**INSPECTOR'S REPORT ON AN APPLICATION
FOR A CERTIFICATE OF AUTHORISATION
FOR A CLOSED LANDFILL**

TO:	David Flynn, Director	
FROM:	Seán Byrne, Inspector	Circular Economy Programme
DATE:	18 June 2024	
RE:	Application by Kerry County Council for a Certificate of Authorisation for a closed landfill at Dingle Historic Landfill, Kilfountan, Dingle, Co. Kerry . Certificate of Authorisation Register Number H0203-01 .

Figure 4: Surface water (SW) monitoring, groundwater & gas (BH) monitoring and trial pit (TP) locations

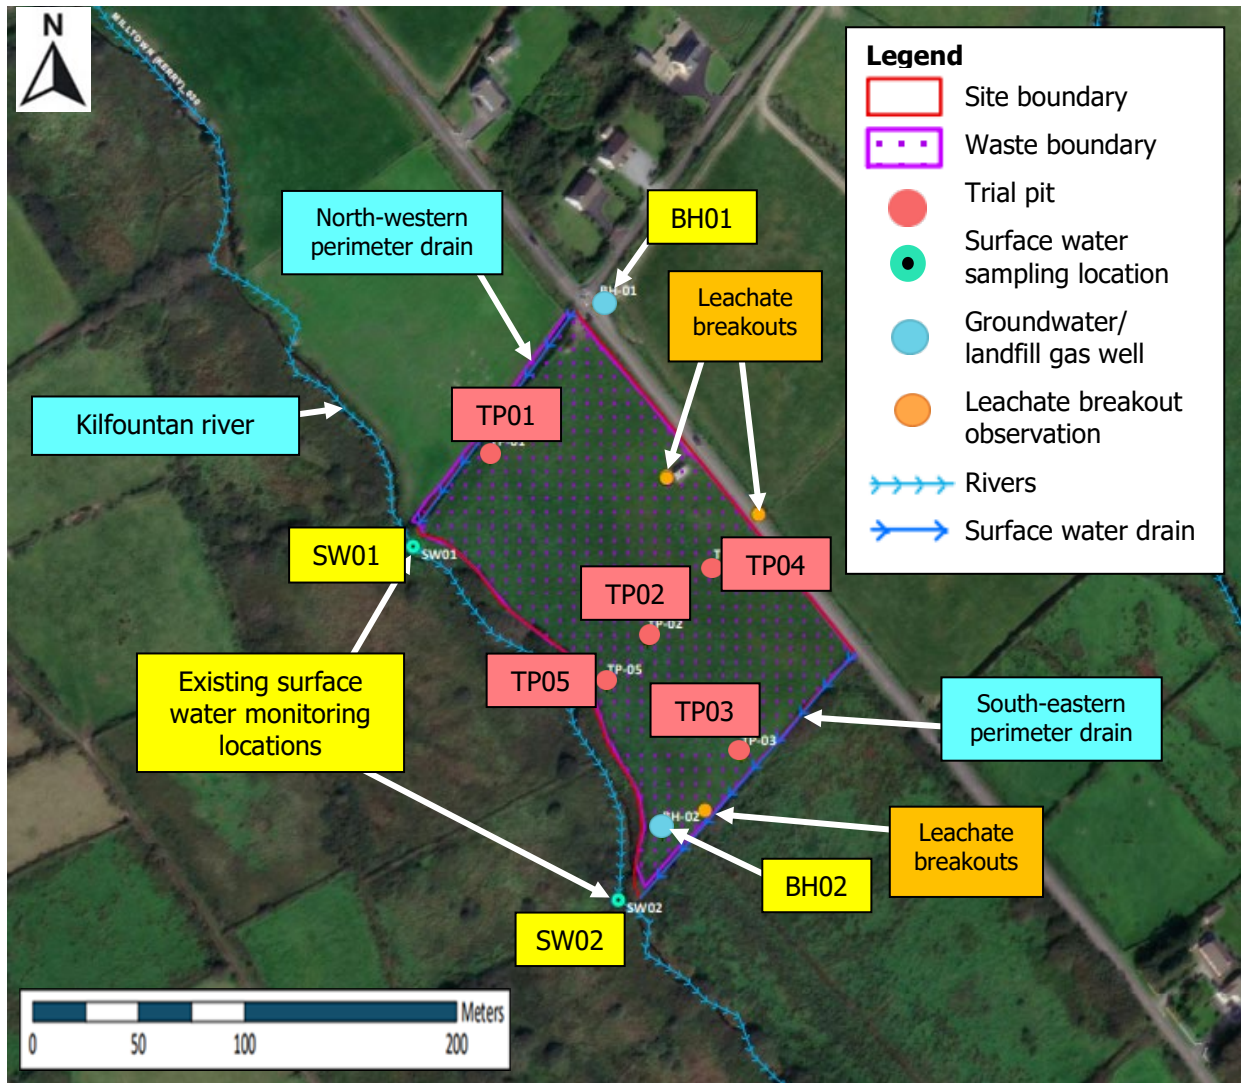
Hydrology	<p>The site is located within the Laune-Maine-Dingle Bay catchment (Catchment Identification Number: 22) and the Ballynahow Commons sub-catchment (Sub-Catchment Id: 22_19).</p> <p>The surface water land drains along the north-western and south-eastern boundaries discharge into the Kilfountain river (waterbody code: IE_SW_22M030400, segment code: 22_1196) which flows in a south-easterly direction, as shown in Figures 1, 2 and 4. The Kilfountain river discharges into the Milltown river (waterbody code: IE_SW_22M030400, segment code: 22_4629) c.470m downstream of the site. The Milltown river discharges into Dingle harbour approximately 1.1km downstream of the site.</p> <p>The Water Framework Directive (WFD) status assigned to both the Kilfountain and Milltown rivers is Moderate. Anthropogenic pressures are classified as significant pressures impacting the Milltown river¹. Other identified pressures are urban run-off, urban waste water discharges, Section 4 discharges, invasive species and channelisation. The WFD Status assigned to Dingle Harbour (European code: IE_SW_240_0000) is High.</p> <p><i>Surface water monitoring</i></p> <p>Two rounds of surface water monitoring were carried out on 17 July 2019 and on 4 September 2019 at two monitoring locations, SW01 and SW02, on the Kilfountain river, as shown in Figure 4. Upstream</p>

monitoring point SW01 is located adjacent to the western corner of the site and downstream monitoring point SW02 is located adjacent to the southern corner of the site. Table 1 below shows the monitoring results for manganese which exceeded the relevant parametric value and ammoniacal nitrogen for which the limit of detection was above the environmental quality standard (EQS).

The tabled results show exceedances of the parametric value for manganese at both locations, with the downgradient concentrations being higher than the upstream concentrations. The exceedances at the upstream location SW01 indicate that other sources may also be affecting water quality in the Kilfountain river.

The monitoring results also showed that the upstream concentration of suspended solids in July 2019 (21mg/l) were lower than the downstream location (71.6mg/l), indicating that the landfill is potentially affecting surface water quality. No other significant differences between the upstream and downstream concentrations for other monitored parameters were noted. Overall, the monitoring results indicate that the landfill may be impacting on water quality, however the impact is considered not to be significant. The Tier 3 assessment states that although the surface water monitoring doesn't suggest the site is actively causing a deterioration in downstream water quality, there is still a potential pathway for leachate to migrate to the river.

Condition 3.9(d) and Schedule A.3 require quarterly monitoring of surface water as outlined in Section titled 'Proposed remedial actions' below. In addition, Condition 3.9(g) requires that the limit of detection of the monitoring methods utilised shall be below the relevant standard reference values and parametric values.

Figure 5: Groundwater flow direction and groundwater borehole (BH) locations

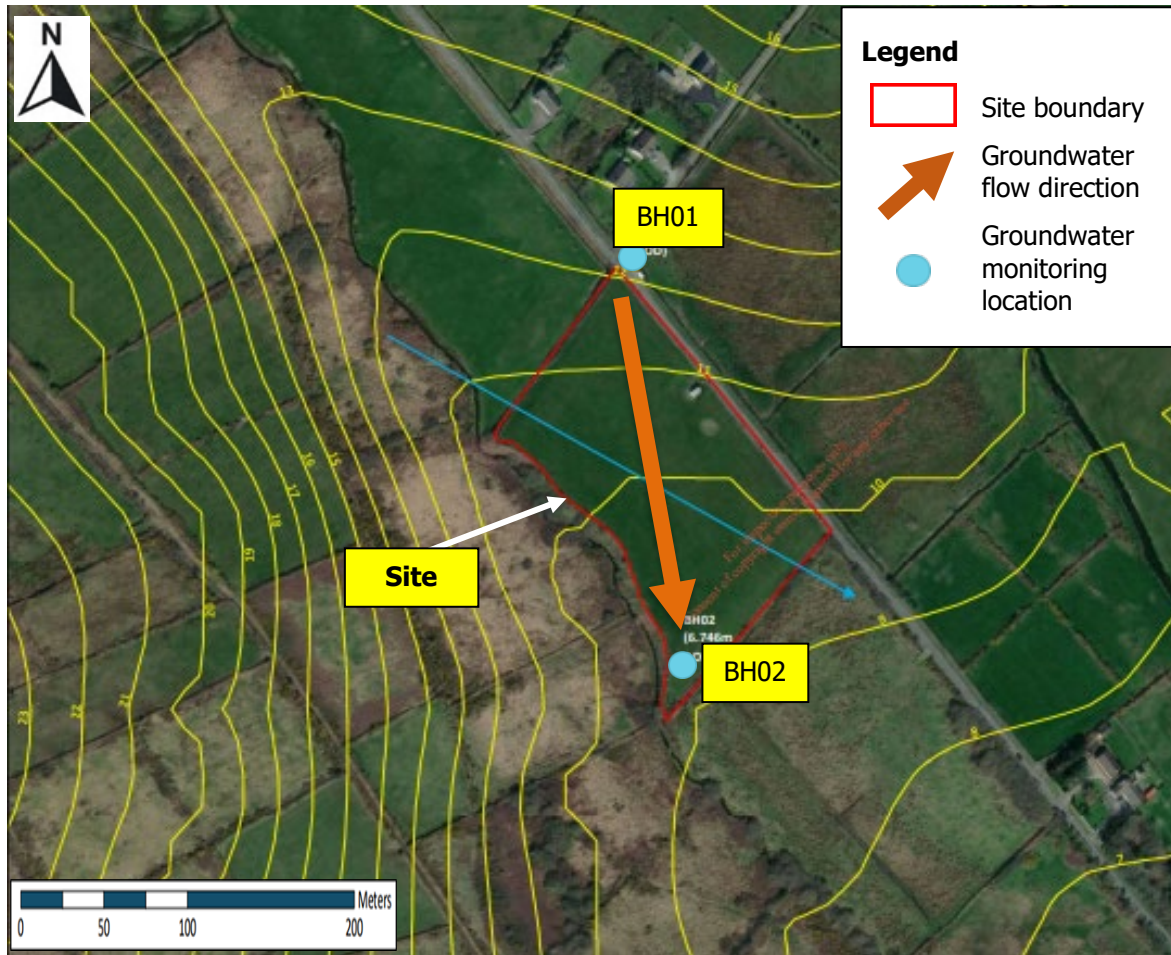
The closed landfill site lies within the Dingle ground waterbody (GWB Code: IE_SW_G_033). This ground waterbody has Good WFD Status and is Not at risk. The site is underlain by a bedrock aquifer which is classified as a Locally Important Aquifer – Bedrock which is Moderately Productive only in Local Zones (LI). The aquifer vulnerability beneath the site is Moderate. Groundwater flows in a south-easterly direction, as shown in Figure 5.

Groundwater monitoring was carried at boreholes BH01 and BH02 on 17 July 2019 and on 4 September 2019, as outlined in Table 5 below and shown in Figures 3, 4, 5 and 7. Borehole BH02 is located within the waste body however groundwater in this borehole was measured at 3.7m below waste, as outlined in Appendix 1.

It is considered however that a quarterly monitoring frequency is appropriate initially given the groundwater monitoring exceedances set out in the Table 5 above and/or due to the limits of detection being above the relevant GTVs for a number of parameters. Accordingly, Condition 3.9(e) requires groundwater monitoring in accordance with Schedule A.4, which requires a quarterly monitoring of groundwater at the locations recommended by the applicant.

Figure 7: Area to be capped, the proposed gas vent and proposed gas monitoring boreholes

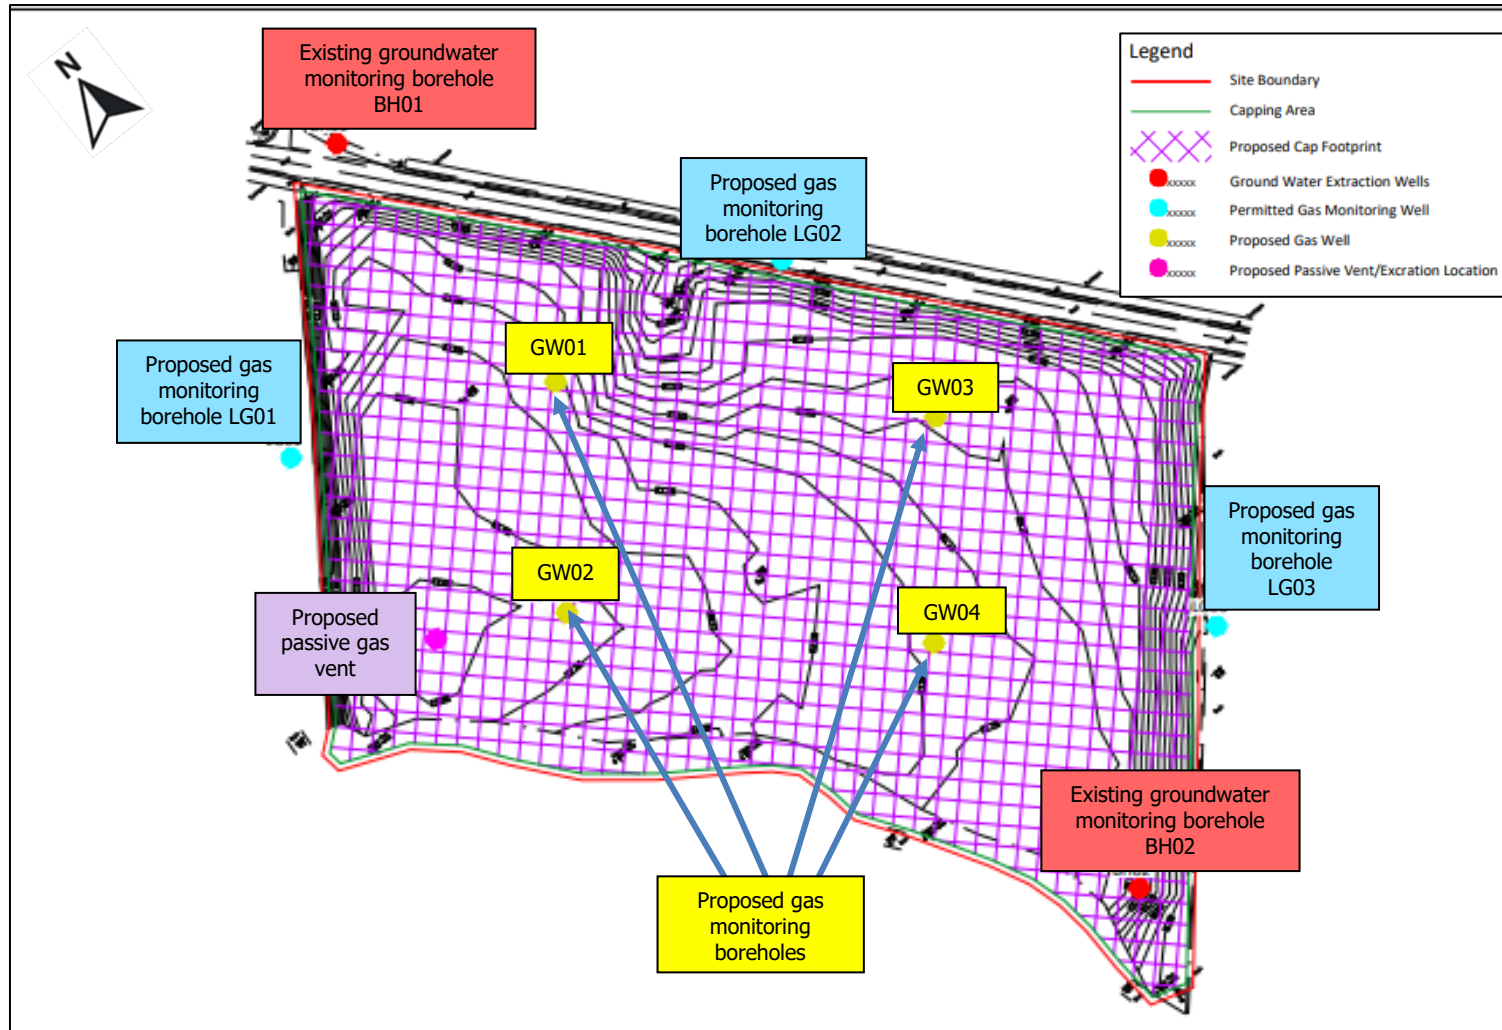
The applicant's Tier 3 assessment recommends a landfill gas collection system comprising of an under-liner gas collection geocomposite or similar approved stone drainage layer. The Tier 3 assessment further recommends that the gas collection layer makes provision for passive venting of gas above the liner with methane oxidation if required. The Tier 3 assessment states that gas vents, if required, shall terminate at least 3m above ground surface and be detailed to prevent rainfall ingress and insertion of ignition sources such as cigarettes or other and that biological methane oxidation filters, if used, shall be excavated into the cap, fenced and isolated from pedestrian, vehicular or animal activities. It is noted that the applicant recommends one gas vent within the north-western corner of the site, as shown in Figure 7.

The Tier 3 assessment further states that the gas collection system design will require *'a gas pump test to define gas flow rate and gas quality, a gas management risk assessment to mitigate environmental pollution in accordance with best practice, measures to mitigate risk of asphyxiation and explosion and an updated gas prediction model.....to facilitate selection of the most appropriate landfill gas management solutions be venting and/or oxidation as may be required.'* The Tier 3 assessment further states that the existing wells on site shall be capped and retained for future monitoring as may be required and the vertical wells used for the gas pump test shall be used for future landfill gas monitoring and or extraction as may be required.

<p>proposed boreholes within the waste body GW01 to GW04, the three proposed perimeter gas monitoring wells (LG01 to LG03) outside the waste body, as shown in Figure 7, and at any future oxidation or venting outlet.</p> <p>Due to the fact that gas remedial measures have not been finalised and the applicant is requesting a gas pumping trial, it is considered that quarterly rather than annual gas monitoring is carried out. Accordingly, Condition 3.9(c) requires quarterly monitoring of landfill gas, at the locations requested by the applicant, in accordance with Schedule A.2. Additionally, Condition 3.1(l) requires continuous gas monitoring, gas vents and gas alarms in the on-site building. The recommended certificate of authorisation allows for the importation and use of soil and stone to complete the works.</p>
Proposed aftercare monitoring and assessment:	<p>Monitoring as specified in Condition 3.9 and Schedule A of the recommended certificate of authorisation.</p> <p>Validation report to be submitted within 6 years.</p>

Condition 3.1(d) requires carrying out a gas risk assessment, including gas pumping trial if required, to inform the final design of the gas management system at the facility. Condition 3.1(e) requires that the final design shall be in accordance with the EPA Landfill Manuals – Landfill Site Design and shall be submitted to the Agency for approval prior to implementation. Condition 3.1(e) further requires the installation, operation and maintenance of a gas management system. This system shall include vertical gas vents, and any infrastructure, including a biological methane oxidation filter, as may be recommended by the findings of the gas risk assessment, as per Condition 3.1(d). Condition 3.10 requires the local authority to carry out a biannual review of the gas management system.
